# **Springbank Off-stream Reservoir Project review**

## **Review of hydrogeology, groundwater modelling, water quality & geochemistry, and climate considerations**

The Springbank Concerned Landowners Group (SCLG)

The Natural Resources Conservation Board  
Application No. 1701

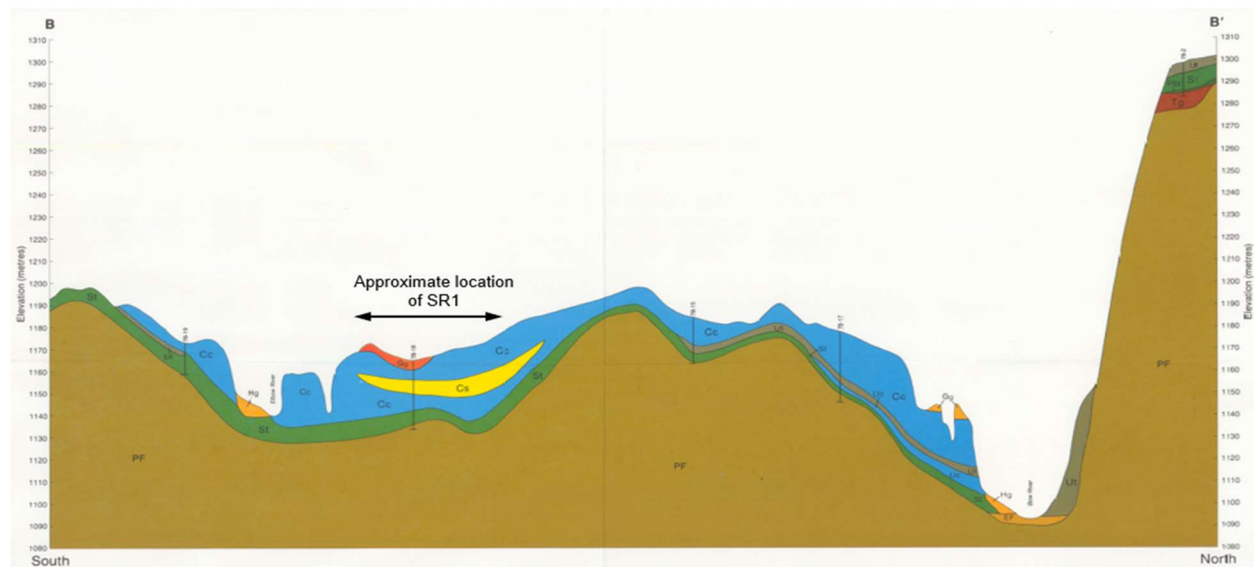
According to Morin (1986), in his review of surficial geology in the Calgary urban area, the glacial deposits in the immediate areas of the SR1 represent isolated surface deposits of fluvial gravel (Gg), followed by Calgary Formation deposits ranging from clay (Cc) to fluvial sand (Cs), and then till of the Spy Hill Formation (Lower Unit), which consists of 40-45% silt and 40-45% clay (Figure 1).

To understand the hydraulic properties of deposits like the overlying glacial gravel (Gg), Calgary Formation lacustrine clays (Cc) and fluvial sands (Cs), and the Lower Spy Hill Formation till (St) the applicant conducted a number of field-based hydraulic conductivity (K) tests. These tests are designed to measure the in-situ ability of the sediments to transmit water. A number of these tests were also conducted in the Paskapoo Formation bedrock to understand their water transmitting properties. Of the 46 tests performed, only three were conducted in the overlying surficial deposits, and only one in the uppermost surficial clay (i.e. the primary barrier to vertical flow beneath the SR1 reservoir area).

Three K tests, with only one in the primary barrier beneath the SR1 containment area is hardly enough to capture the range of values in the overlying sediments given their importance to seal off water leakage through the base of the structure into the underlying bedrock. Most of the area's residents have their water wells completed in the underlying bedrock and use that water for human consumption, livestock watering and other day-to-day needs. Concerns have been raised by the SCLG regarding how the operation of the SR1 reservoir will affect the water levels in their wells (i.e. will some become flowing artesian?) and the chemical quality of the water (i.e. will things change due to the introduction of contaminants?).

**Figure 2.** Similarity in water level responses in wells completed in the glacial deposits (upper graphs) and bedrock intervals (lower graphs).<sup>2</sup>

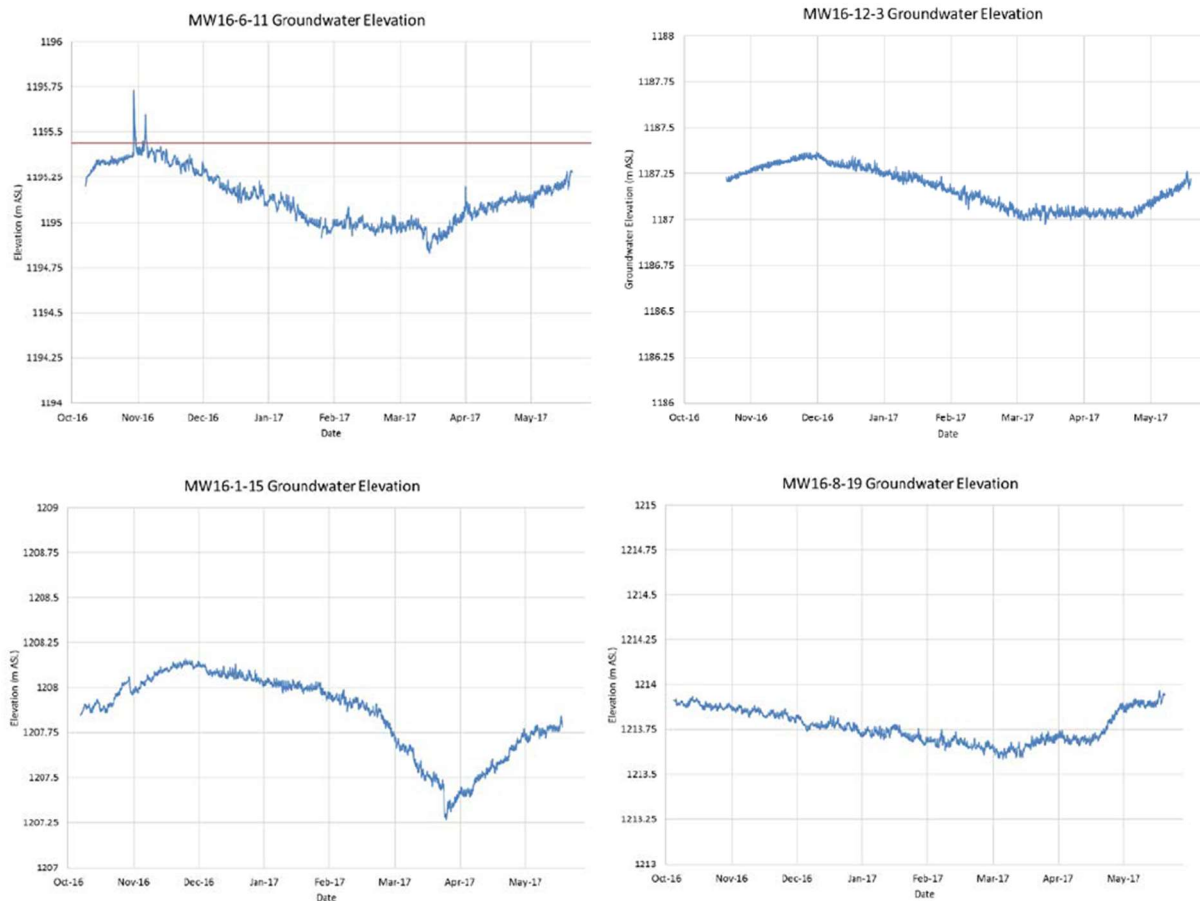
Hydrographs from monitoring wells installed by the applicant during field investigation at the SR1 site provide evidence of hydraulic connectivity between the overlying glacial deposits and the bedrock intervals, further supporting the role of fractures in providing pathways for groundwater movement. Figure 2 is a comparison of hydrographs generated from wells completed in the surficial deposits and bedrock beneath the site. It is clear that the wells in both intervals are showing similar water level responses.

**Figure 3.** Distribution of hydraulic conductivity (K) values in various Stantec model layers (Stantec 2019). (Note: black trapezoid shows approximate location of reservoir footprint)

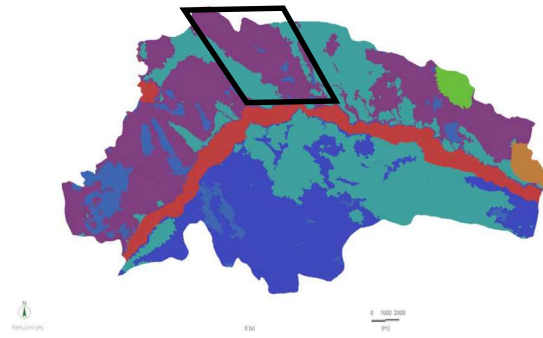
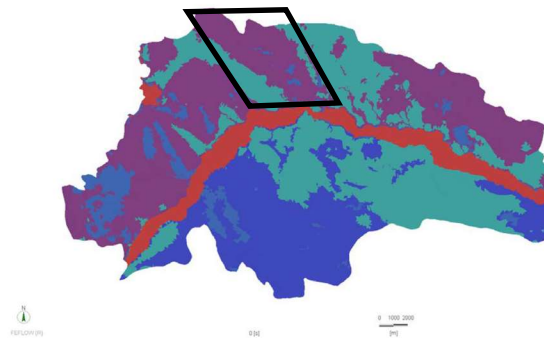
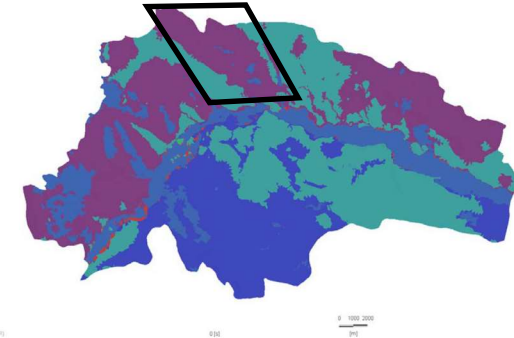
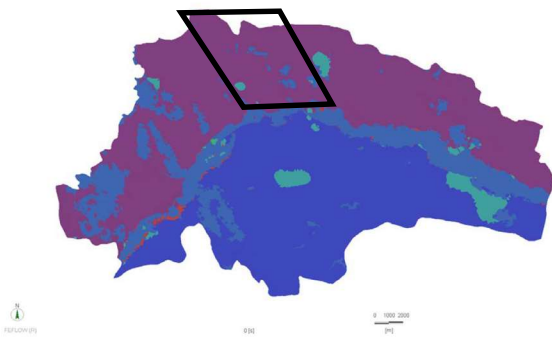
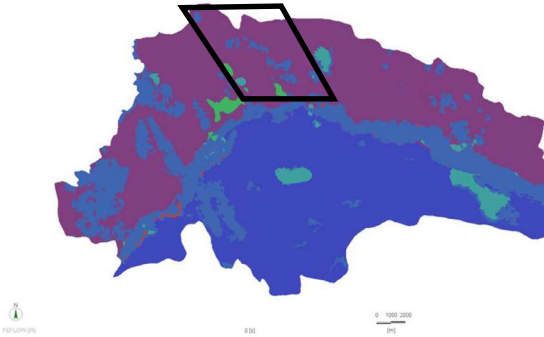
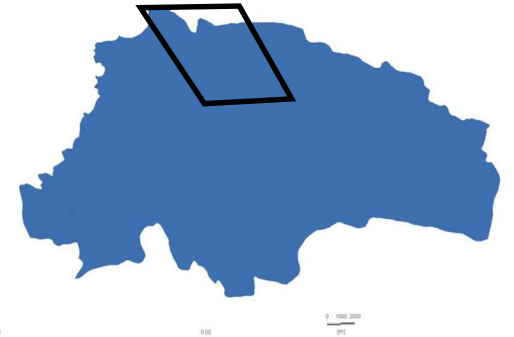
Again, this seepage rate has been estimated based on the hydraulic conductivity values used in the model, which are arguably too low when considering the presence of fractures in the overlying surficial deposits. It is quite possible that this flux value may be an order of magnitude, or more, higher. That being the case, the additional leakage of water through the base of the SR1 reservoir down into the bedrock is a concern. In addition to the possible translocation of natural contaminants from the surficial sediment into the bedrock, there is the risk of contaminants picked up by the flood waters upstream of the site (i.e. from Redwood Meadows and Bragg Creek) migrating down into the bedrock intervals when the reservoir is containing flood water.

From a review of Figure 4, taken from the Stantec report (pdf page 127) there seems to be an error with that statement. Closer review indicates that the majority of residual values lie above the zero-line, which is a systemic bias. The simulation of “higher than observed” hydraulic heads will adversely affect the seepage estimates provided, making them lower than anticipated due to less of a vertical gradient downward through the surficial deposits towards the bedrock.

**Figure 4.** Graph of residual values from groundwater numerical model showing positive bias between simulated versus measured hydraulic heads.

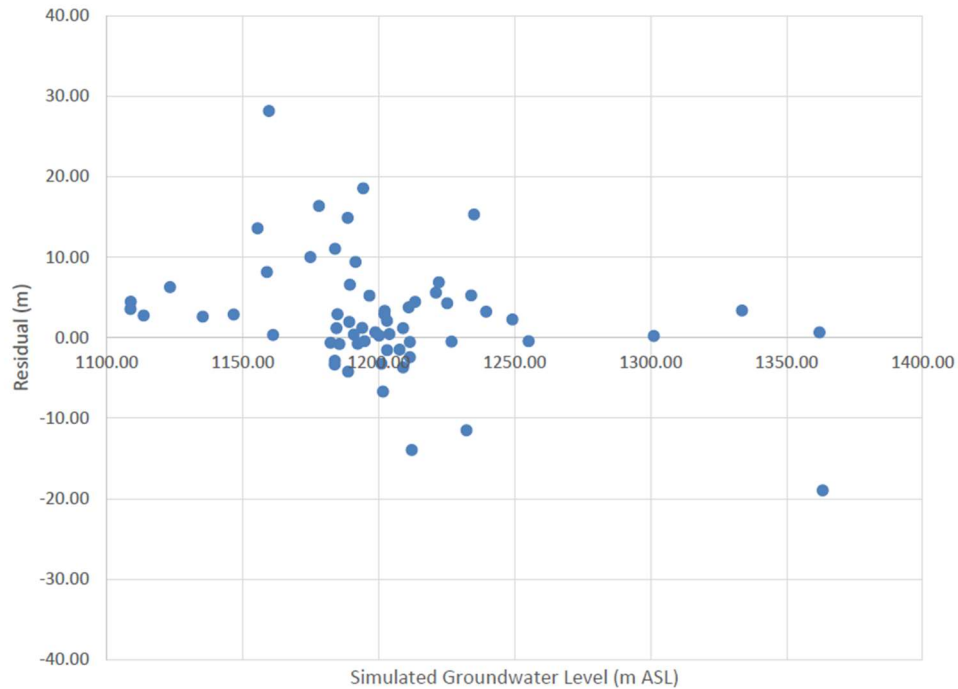
There is also an issue related to how well the groundwater model is representing simulated hydraulic heads. The statement is made on pdf page 127 of Exhibit #110 (Stantec 2019) that:

*“Systemic bias in the simulations can be also evaluated by comparing the residuals to the simulated water levels. Figure 4-15 presents a plot of the residual values at each of the calibration points versus its simulated head. The plot indicates that residuals are distributed both above and below the zero line, again indicating no systemic bias in the calibration.”*

Figure 6. From pdf page 478 of Exhibit #110 (Stantec 2019)

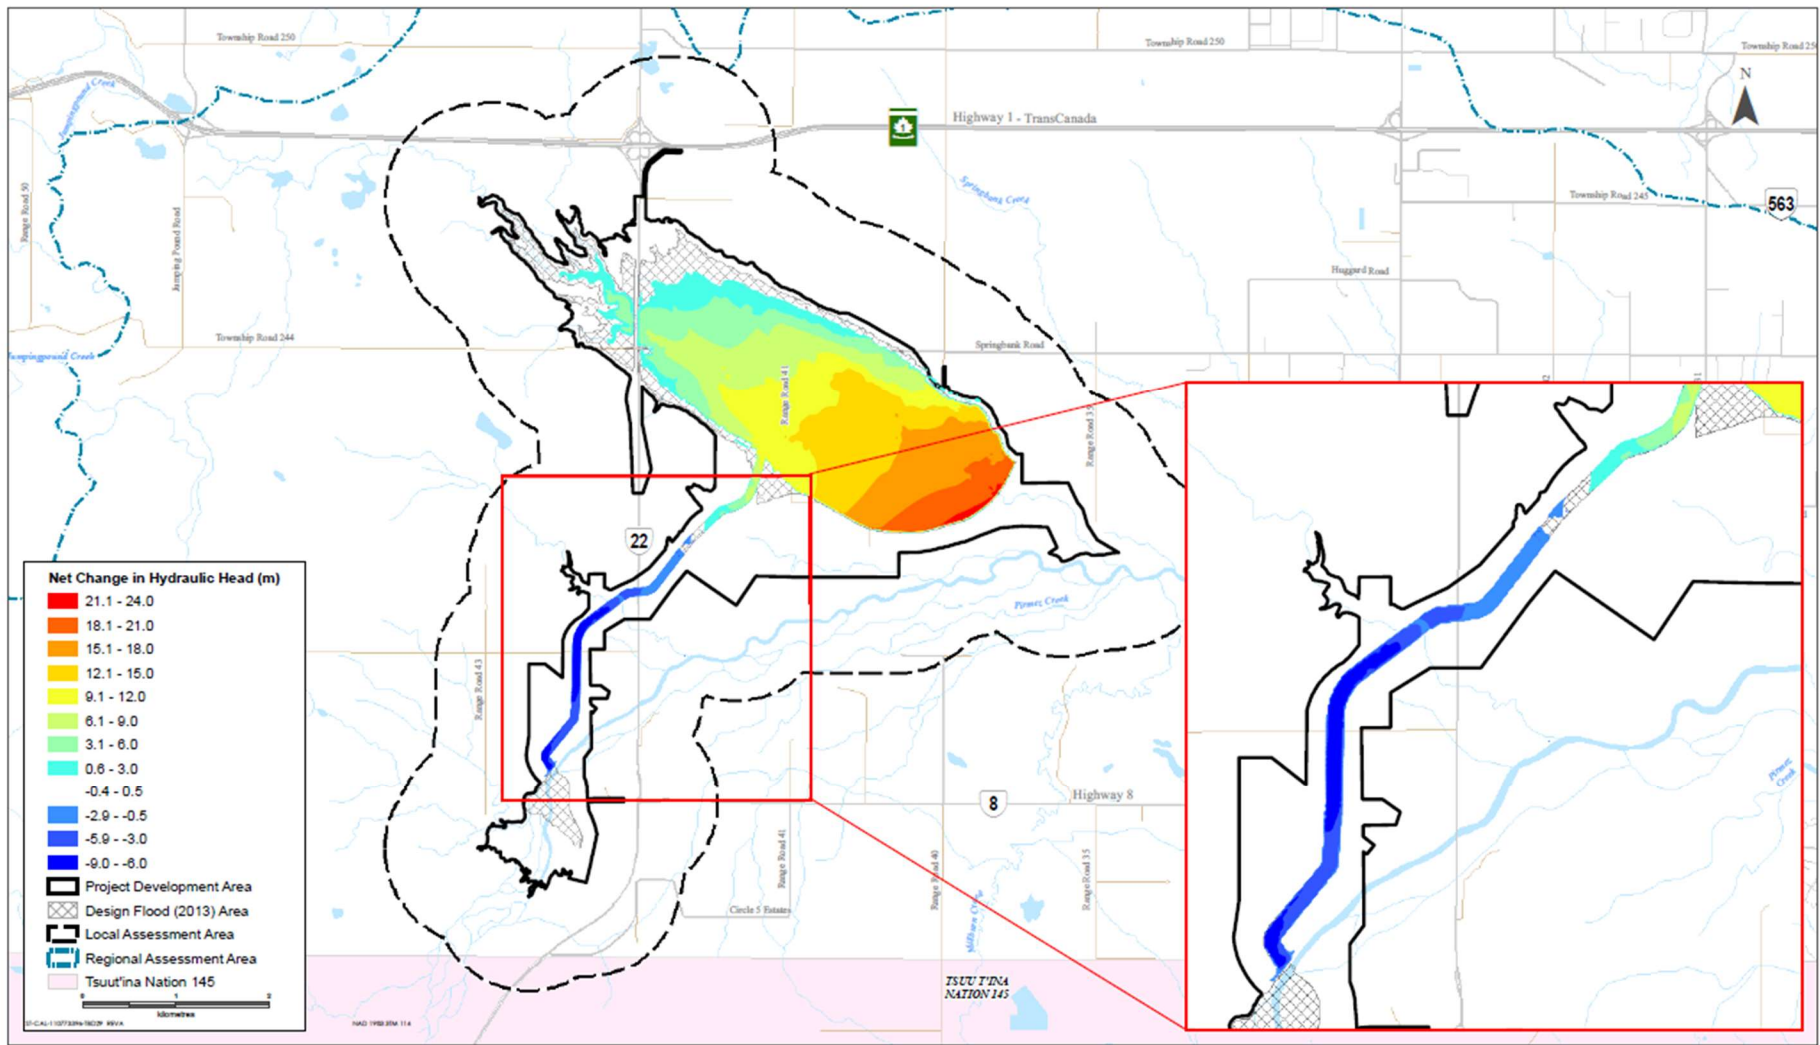
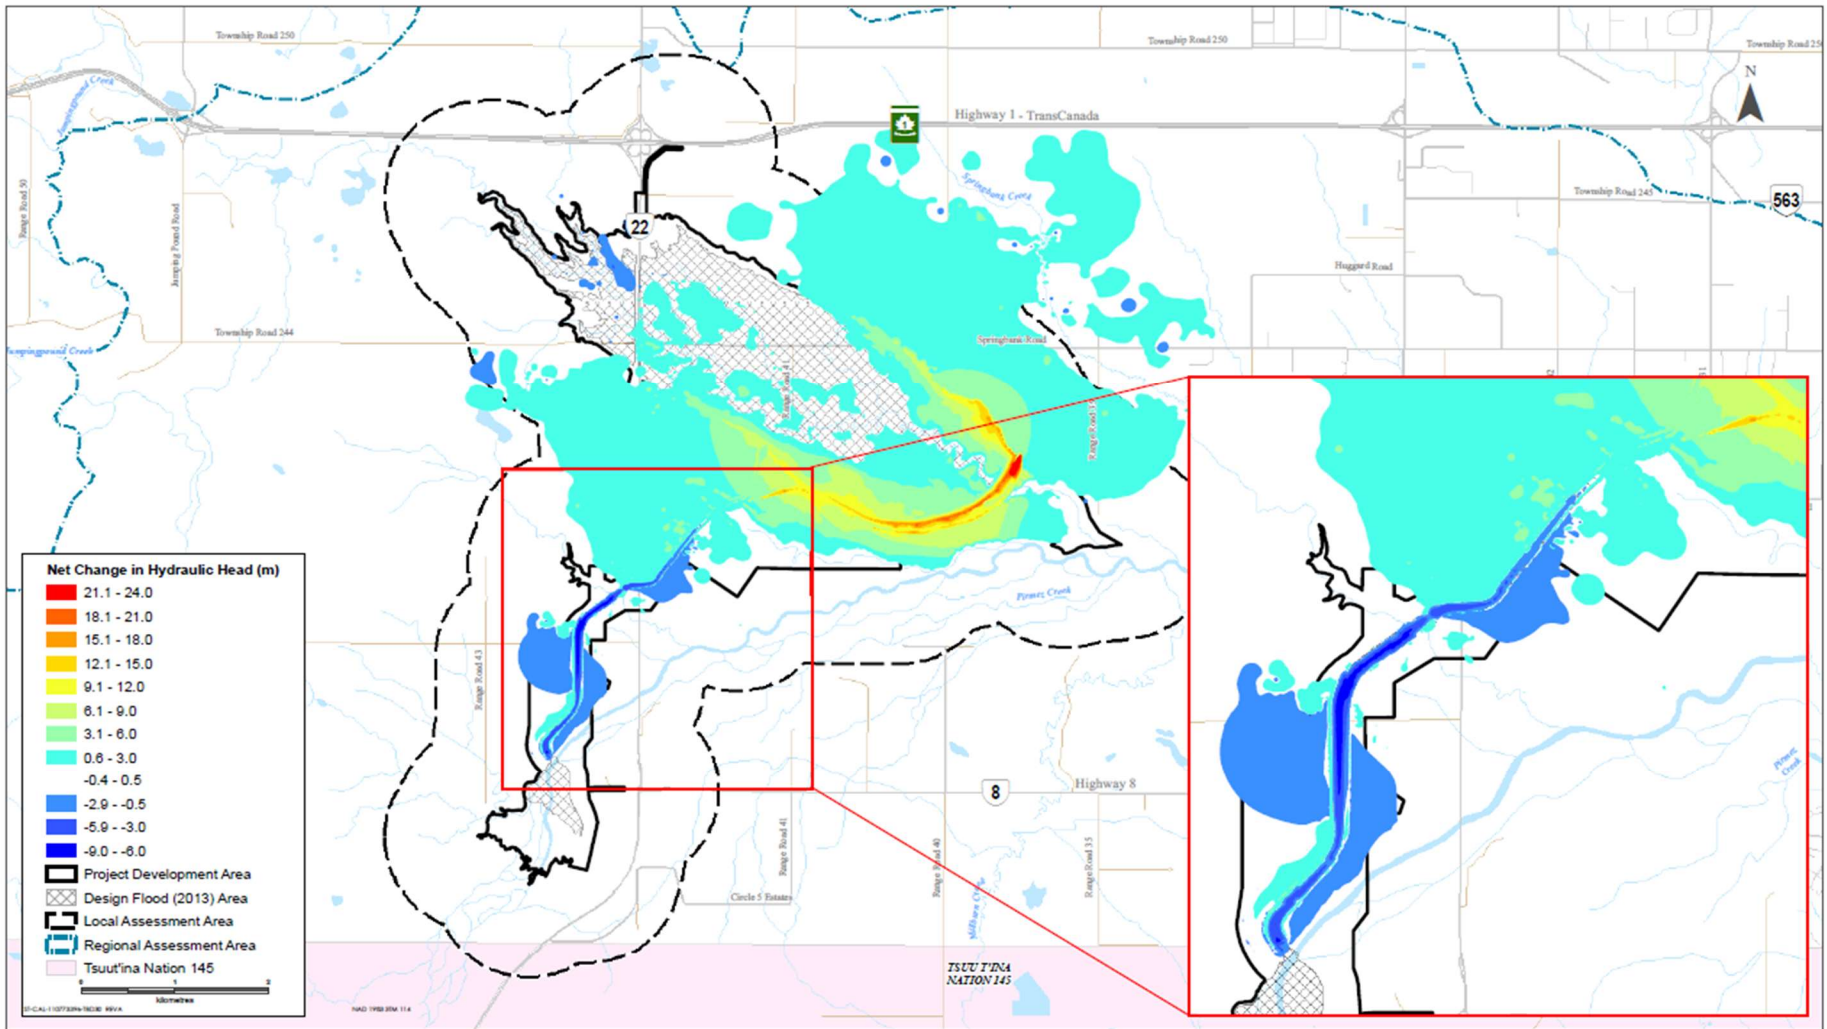
It is obvious from the model results that the simulated net change in hydraulic head conditions is generally confined to the immediate area around the reservoir. This is noted when comparing the project effects for the design flood basis (PXX1/EXX1) to the baseline condition (PXX0/EXX0) with no water in the SR1 reservoir. This is shown in Figures 5 to 7 for various sensitivity scenarios listed in Table E.11-1 on pdf page 472 of Exhibit #110.

It clear that the three order of magnitude increase in hydraulic conductivity values for the till in Sensitivity Scenario 1 has little effect. It is also clear that Sensitivity Scenario 2 (with an increase in storativity and specific yield) has little effect. The difference is shown in the baseline case where increased hydraulic head conditions up to 9 m or so extending outwards for the footprint of the earthen dam.

Although the maps provided in Figures 5-7 are useful to some degree, what is lacking is a full accounting of the resulting changes within or between the model layers under the various scenarios (i.e. water balance and fluxes). However, all that is provided by the applicant is a summary table on pdf page 125 of Exhibit #110 (Table 4-2: Residual Statistics from Steady-State Calibration) indicating that the model results are acceptable. This in no way clarifies whether there are issues in certain parts of the model domain versus others and is just an average of entire model domain. The considerable difference in observed versus simulated head of -18.98 to +28.14 metres, as indicated in Table 4-1 on pdf page 123 of Exhibit #110 (i.e. Observed versus Simulated Heads and Calculated Residuals) and shown in the preceding Figure 3 of this submission, is a clear indication of the issue with accurately simulating observed conditions. This is to be expected, because models are a gross simplification of actual conditions and are based on the input parameters uses. As such, they rarely provide accurate and precise answers.

**Figure 8.** Piper plot showing major ion composition of the water contained in the surficial (glacial) deposits and the underlying bedrock.<sup>4</sup>

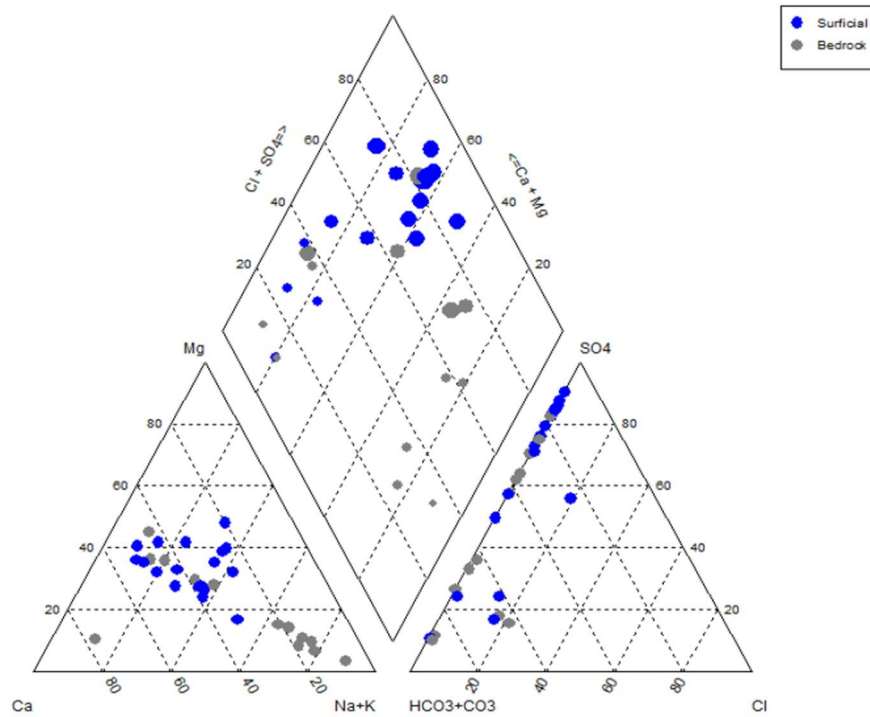
The proponent has conducted baseline surveys of the groundwater beneath the SR1 project area. The results of this assessment are communicated in the Table 3-4: Summary of Groundwater Analytical Laboratory Results on pdf pages 93-97 of Exhibit #100 (Stantec 2019). A comparison of the groundwater sampled from the glacial deposits with that in the underlying bedrock was made by the applicant and the results are provided in Figure 8. It is clear from a review of that figure that the groundwater sampled from the surficial deposits is chemically similar to the groundwater sampled from the upper bedrock. This is another indication of hydraulic communication between the two intervals - this time chemically versus physically, as previously noted in Figure 2.

Further review of the baseline water quality reveals some other interesting aspects. With respect to trace elements, the presence elevated selenium (Se) and uranium (U) concentrations in the groundwater sampled from the clay and till deposits has been noted. In fact, selenium values as high as 0.056 mg/L and uranium as high as 0.04 mg/L have been recorded. These concentrations are above the maximum acceptable

concentration (MAC) for Canadian drinking water of 0.050 and 0.020 mg/L, respectively<sup>3</sup> based on health-related effect. The effects of exposure to elevated selenium include hair loss, tooth decay, weakened nails, and nervous system disturbances, while those for uranium (a radioactive element) include impact to the kidneys. The occurrence of these elements is most likely connected to natural processes, but nevertheless does indicate that the geochemical conditions are suitable for their mobility from the local sediments into the local groundwater.

**Figure 9.** Eh-pH diagrams for selenium, left and uranium, right.<sup>5</sup> (Note: red shaded areas represent conditions anticipated for the local groundwater conditions based on ammonia, iron, manganese and nitrite values)

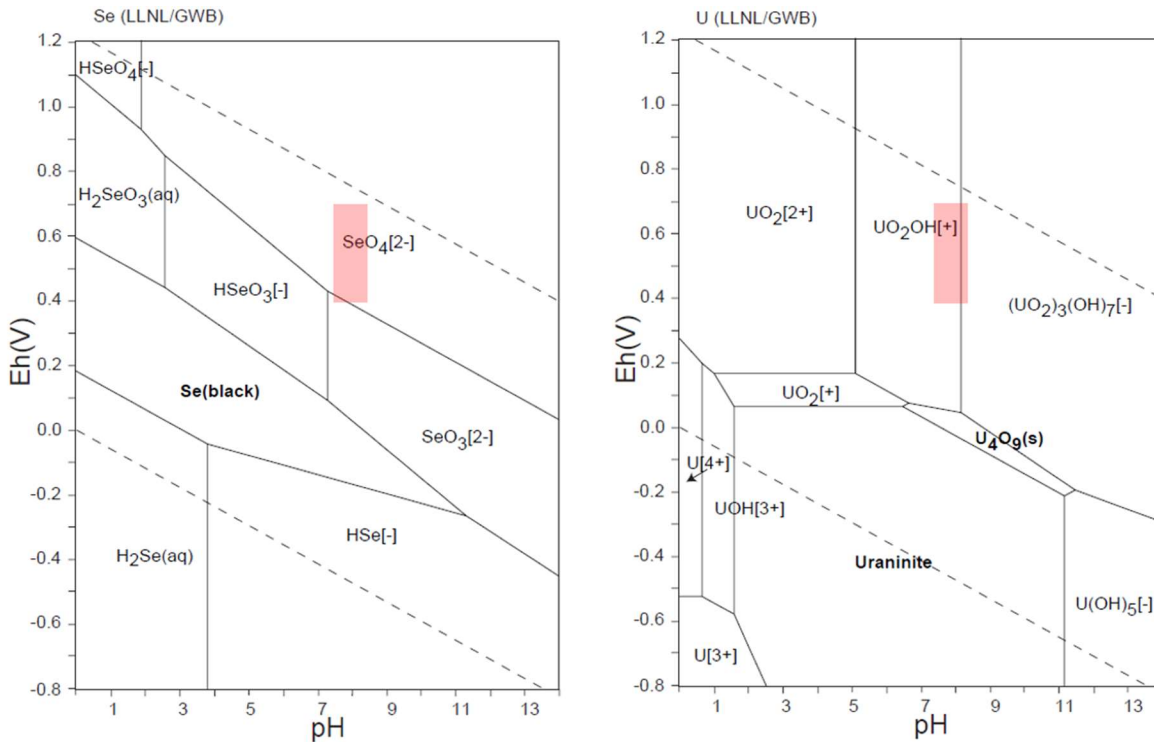
There are two major concerns related to these harmful trace elements and the location and operations of SR1. First, the operation of the reservoir under flood conditions will provide a large driving head of water

at the base of the structure that will serve to flush these trace elements, and any other contaminants present in the flood accumulated flood waters, down into the bedrock, in effect compromising the water quality in that interval and impacting the drinking water supplies of local residents. Secondly, the introduction of well-oxygenated surface water accumulated in the reservoir may lead to additional release of selenium and uranium, and possibly other harmful trace elements, through various geochemical reactions (e.g. ion exchange, mineral dissolution, etc.). Unfortunately, the applicant has not assessed this risk or any other groundwater quality concerns that could arise from the construction and operation of the SR1.
